- 1 -
SEP 13 1985Docket File 8084
LFMB/DCS/PDR
DBangart, RIV
GKonwinski
MShopenn
URFO r/f
LAnderson, RCPD, UTURFO:GRK
Docket No. 40-8084
SUA-1119, Amendment No. 6
04008084510E

MEMORANDUM FOR: Docket File No. 40-8084

SUBJECT: AMENDMENT NO. 6 TO SOURCE MATERIAL LICENSE SUA-1119
FOR RIO ALGOM MINING CORP.

Figure 1 Water Level Monitoring Locations and Drawdown Contours Resulting from Pumping Well OMUT-9. Pumping period from 11-83 to 6-84.

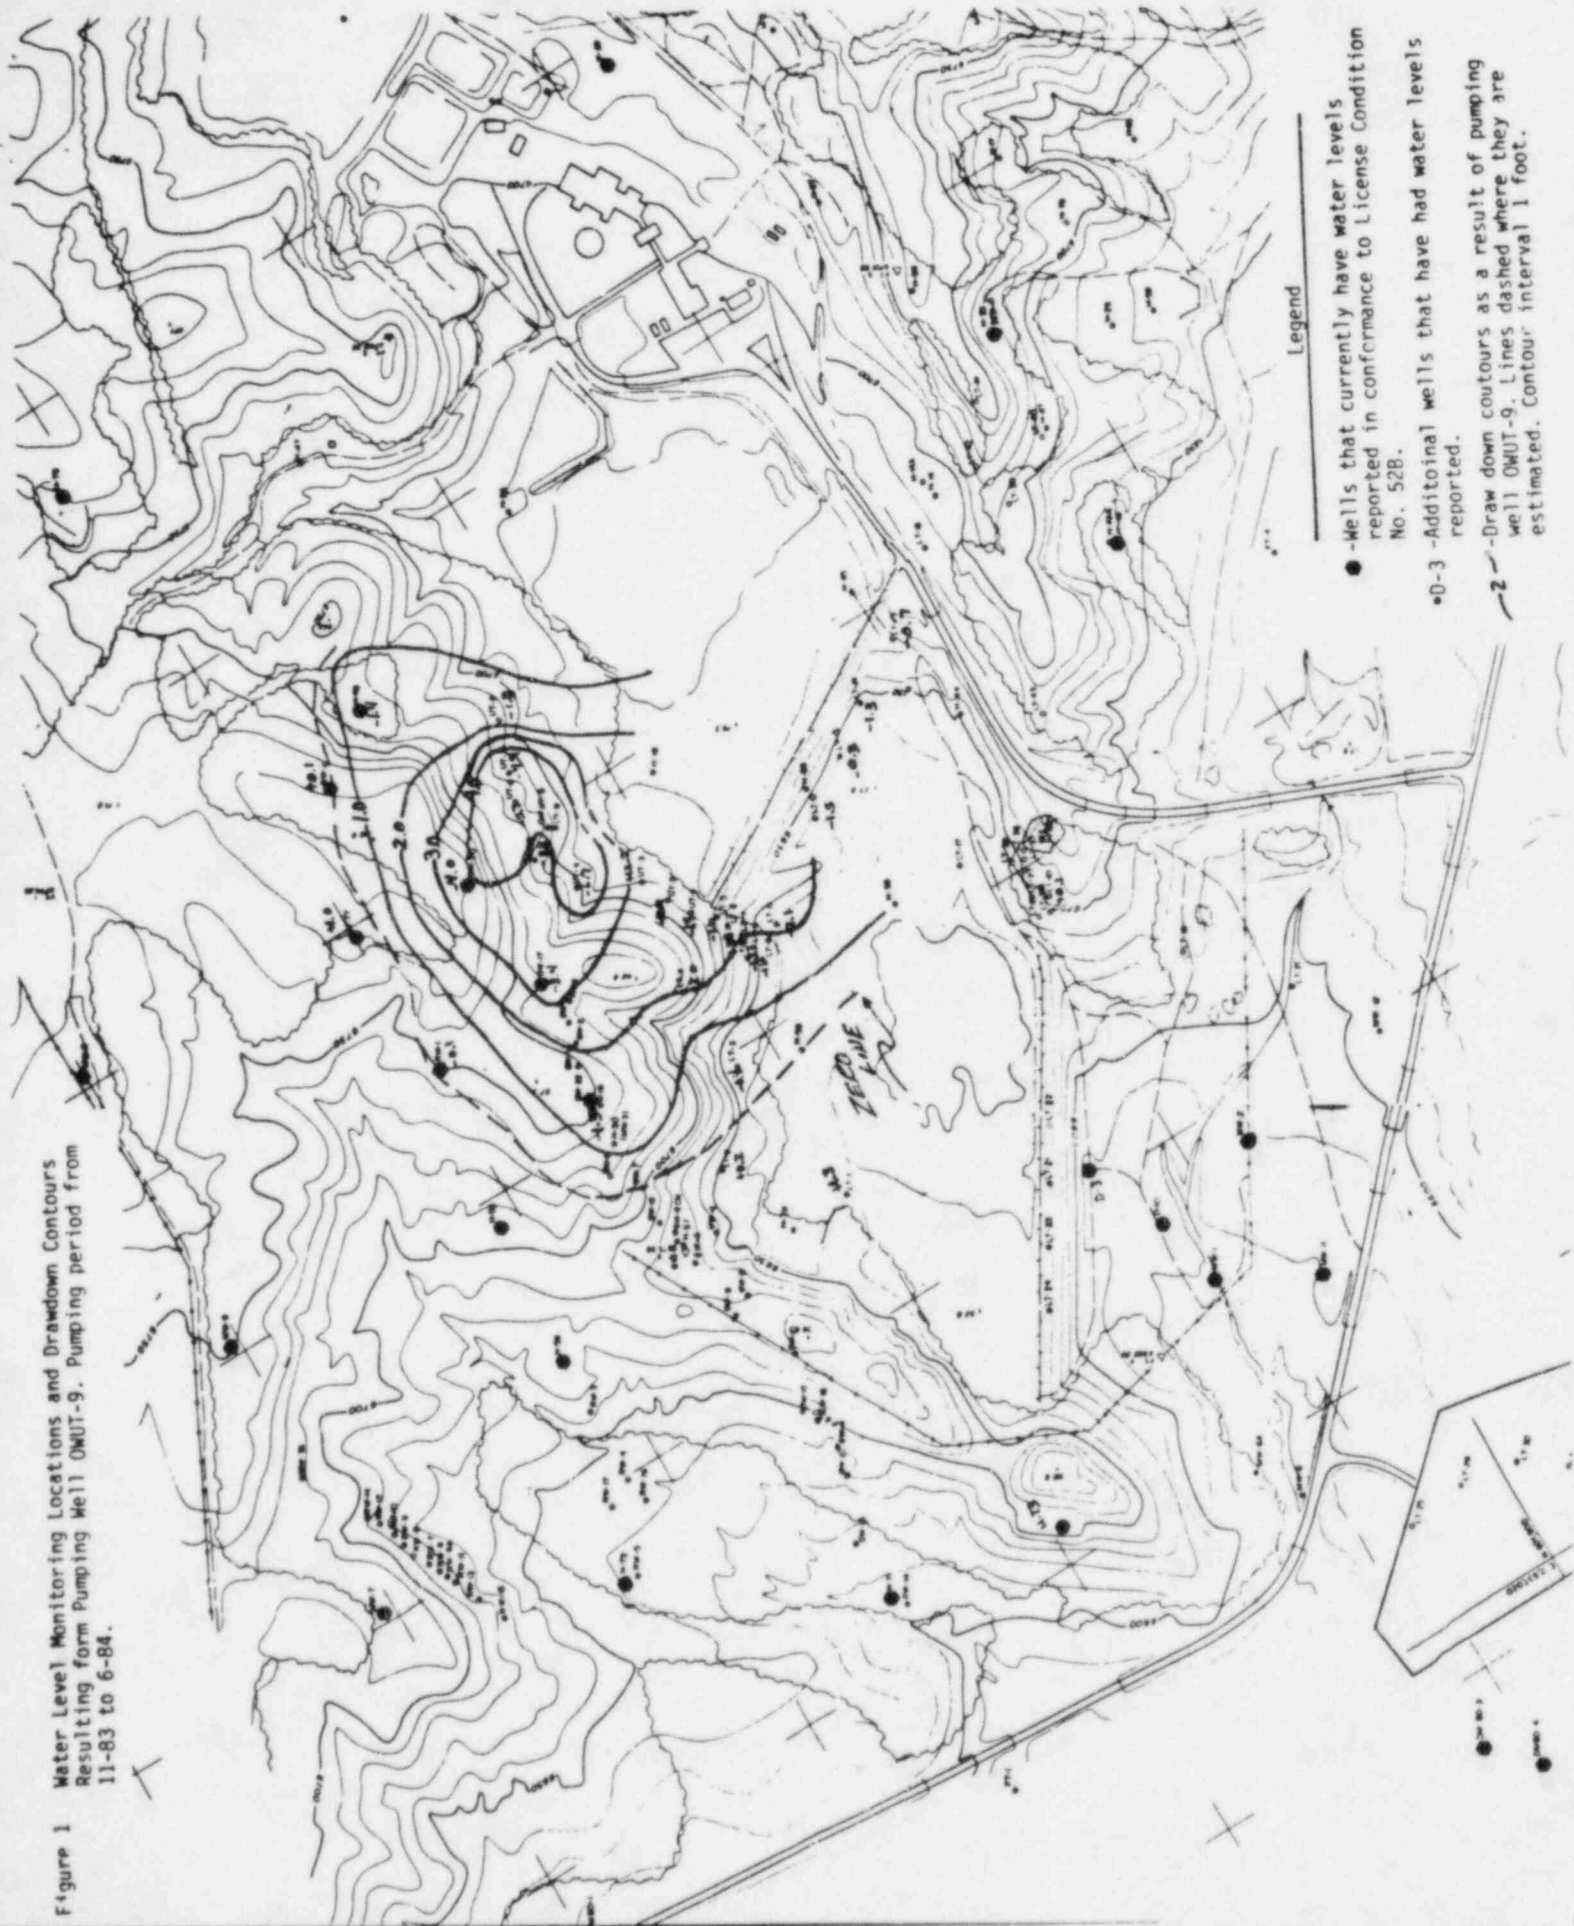
The water level data as shown in Table 1 was submitted in accordance with License Condition No. 52B of SUA-1119. Similarly, the potentiometric contour map, as submitted by Rio Algom, accurately depicted this data. However, because of the ground water divide which exists at the site and the location of the seepage recovery system, the water level data from the above wells is of little value in assessing the overall site potentiometric surface. A more useful set of water level data points could be derived from existing wells near the area of seepage recovery. Such data as compiled in Table 2 are more meaningful for assessing changes in the ground water system. These wells are located in the area of the successful pumping well - OWUT-9. As indicated by data from these wells and as shown in Figure 1, a cone of depression has been created in the vicinity of the pumping well. Figure 1 also shows locations of wells

which routinely have their water level reported to the NRC. Because sufficient water level data beyond June 1984 is not available, the current extent of the cone of depression is unknown. Assessing the cone of depression by recording water levels in adjacent wells yields valuable information for understanding the ground water system at this site and should continue to be reported.

Based upon the above discussion and the lack of current water level data for the wells in the area of the Well OWUT-9, the staff concludes that Rio Algom Mining Corp. should continue to measure water levels in the wells listed in Table 2. The staff further concludes that water levels from Wells H-18, UT-9, H-26, GW-21, GW-8, H-47, GW-23 and H-57 would add valuable data to determining the extent of the cone of depression developed by Well OWUT-9.

- A. Radon monitoring shall be conducted continuously using passive monitoring devices which are exchanged and read at least quarterly.
 - B. The licensee shall implement a ground water monitoring and seepage control program as specified in the submittal dated September 21, 1984. In addition, the licensee shall collect and report water level data from the following:
MW Wells: 1, 2, 4, 5, 6A, 7, 8, 9, 10, 11 and 12;
H Wells: 38, 48, 49, 55, 56, 57, 71, 72, 73, 77 and 78;
LT Wells: 1 through 15; GW Wells: 17, 19 and 20;
RW Wells 1 and 2; UT Wells 1 through 8; D Wells 3 and 10;
and DM Wells 80-1, 80-2, 80-3 and 80-4.
